Reverse Gate Adjustment - Sport Jet 175 XR²

Models Affected

All Sport Jet 175 XR² Models

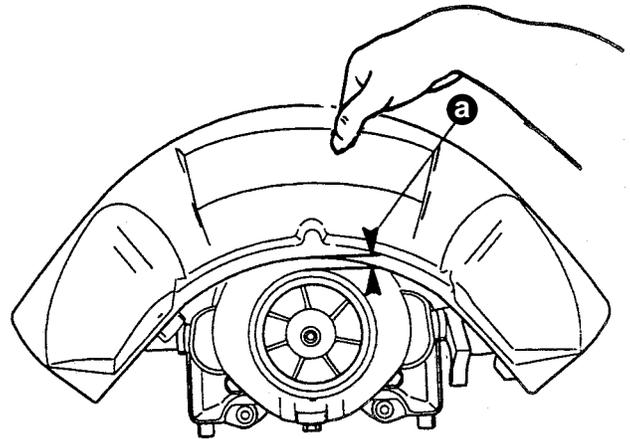
We have received reports from the field of failed reverse gate stops. Review of these failures indicate the cause was due to improper adjustment of the shift cable. If the lower edge of the reverse gate is not 3/8" (9.5 mm) to 1/2" (12.7 mm) above the edge of the steering rudder after removing the shift cable slack in the forward position, damage to the stops and reverse gate may occur.

The shift cable must be adjusted correctly so that the reverse gate does not interfere with water flow coming out of the rudder. If the reverse gate hangs down into the water flow, a vibration may be felt in the control box. If this occurs, reduce throttle immediately and readjust the cable. Improper adjustment may result in pump damage including loss of the reverse gate. Failure to properly adjust the shift cable could result in loss of neutral and reverse, property damage, personal injury or death.

To check shift cable adjustment, first shift the remote control lever into the forward position. Apply a light downward pressure on the reverse gate until all slack is removed from the shift cable. While maintaining the downward pressure to remove the cable slack, measure the distance between the lower edge of the reverse gate and the upper-most portion of the steering rudder (dimension "a" in figure below). This dimension should be between 3/8" (9.5 mm) to 1/2" (12.7 mm). If the clearance is less than 3/8" (9.5 mm), readjust the shift cable as outlined in the installation manual (P/N 90-10164970) or the service manual (P/N 90-852396).

a - 3/8" (9.5 mm) to 1/2" (12.7 mm)
